Certified Action of the City of Raleigh Planning Commission

Case File / Name: SP-23-11 / 425 North Boylan

Staff Report

SP-23-11 / 425 North Boylan – Site Plan Commercial Level Layout

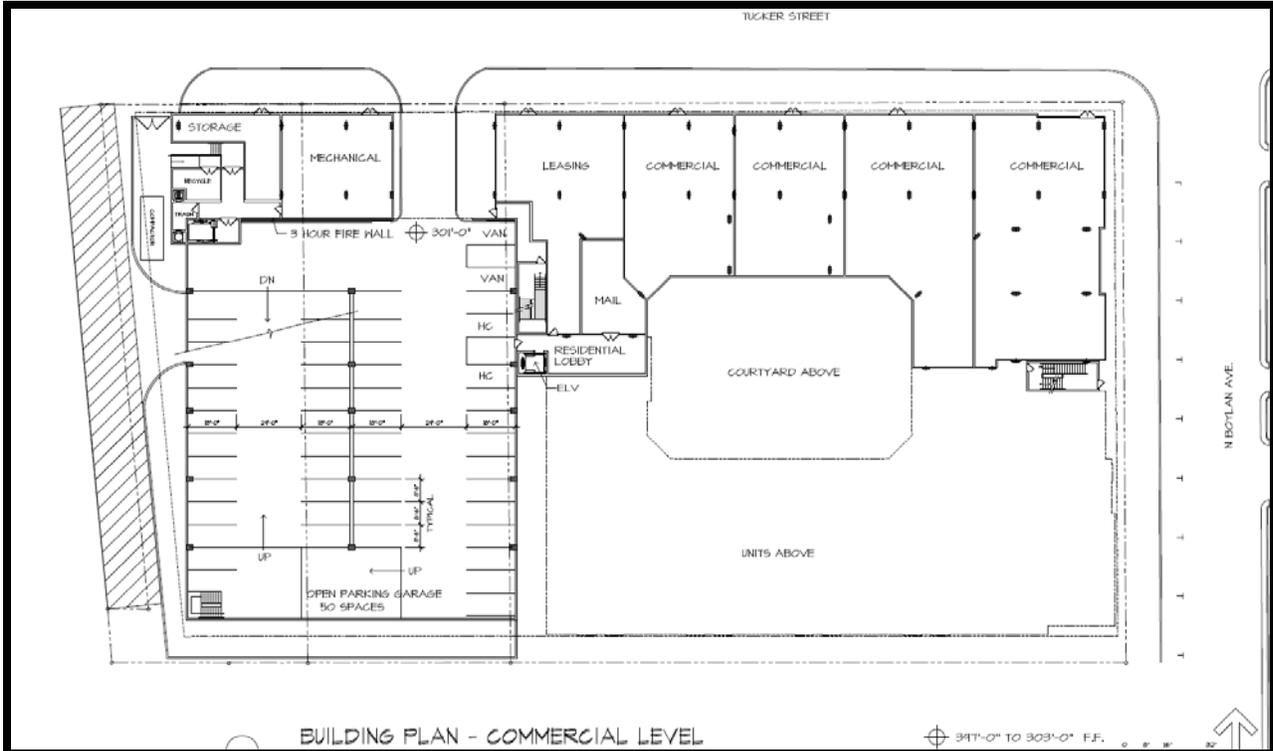
Key Issues: Increase in residential density above 40 units per acre; proposed alternate for providing a 14' wide sidewalk along portions of Boylan Avenue.

**VARIANCES /
ALTERNATES:** The applicants are seeking an open space alternate to allow for stoop encroachments into portions of the required 14' wide sidewalks along Boylan Avenue.

- (4) That in accordance with Code Section 10-2055(d) (4),last paragraph, the Planning Commission approves a reduction to the 14' wide sidewalk along portions of North Boylan Avenue to allow for the encroachment of stoops and stairs serving the residential units;

The applicants are seeking an alternate approval, in accordance with Code Section 10-2055(d)(4), to allow stoops and stairs to encroach into the 14' wide sidewalk (and right-of-way) along Boylan Avenue. The effect of the encroachments reduces the required 14 foot wide sidewalk width by 2' in some places thereby rendering the sidewalk down to a width of 12' for an approximately 94' long sidewalk section. Approximately 40' of the 94' long section is devoted to stoops and 54' is devoted to foundation plantings. The applicants are proposing this alternate because they have a desire for their residential tenants to have a slight separation between their outdoor porches and windows and the public sidewalk. They also feel that this alternate helps transition to the narrower sidewalk existing along Boylan Avenue to the south of the property. The approving body is allowed to make this reduction if it finds that the reduction is in accordance with the general plans for the physical development of the City as embodied in the Comprehensive Plan.

4. To enhance the functional and visual transition between the subject site, which is within the Peace Street Pedestrian Business Overlay District, and abutting properties to the south, which are not, the commission supports the concept of incrementally reducing the sidewalk width along North Boylan Avenue from the full width of the proposed building setback at the corner (with Tucker Street), down to the width of the existing sidewalk to the south, utilizing the balance of the resulting unpaved area for a swale installed per low impact design principles [commensurate with Code Sec. 10-2132.2(d)(5)&(6)].

PEDESTRIAN: A 14' sidewalk is required along the property's frontage on both Tucker St. and Boylan Avenue. Proposed sidewalk locations conform to City regulations with the exception of an approximately 94' long section of Boylan Avenue where the proposed stoops and stairs encroach 2' into the 14' wide sidewalk. The effect of the encroachments reduces the width of the sidewalk down to 12' in some places. Portions of the sidewalks will be located on private property and will be subject to a public sidewalk easement.

SLC appreciates the committees support to request a proposed Open Space Alternate along North Boylan Avenue. For the same reasons mentioned by the committee regarding functional and visual transitions, SLC has proposed a 12 foot minimum sidewalk that transitions to more than the standard 14 feet towards the corner of North Boylan Avenue and Tucker Street where the service and retail services are proposed. The 2 foot encroachment will allow for proposed stoops to residential units that face on to North Boylan Avenue in two locations. There are no doors to any of the service and retail uses along this facade. The existing sidewalk along North Boylan Avenue south of our street frontage is approximately 6 to 8 feet wide (plus an open planting strip) and the properties within that district are no longer within the Peace Street Pedestrian Business Overlay District. While the majority of uses along this corridor are business related, the existing streetscape reflects more of a residential/green feel as opposed to the feel of a commercial width sidewalk where 14' would be appropriate. With regard to low impact design principles, SLC and the City of Raleigh professional staff had a collaborative effort during the Preliminary Site Plan review process to come up with a design that would provide for bio-retention along this frontage and ideas within the 2030 City of Raleigh Comprehensive Plan for a 'Green Street' on North Boylan Avenue. While the City of Raleigh staff were supportive of our initiative and would like to see some of these techniques used in the future, they were not prepared at this time to approve a design proposing low impact design principles. Therefore, no bio-retention swales are proposed and with the exception of the 2 foot encroachment for stoops, the standard concrete sidewalk with trees in grates has been proposed.
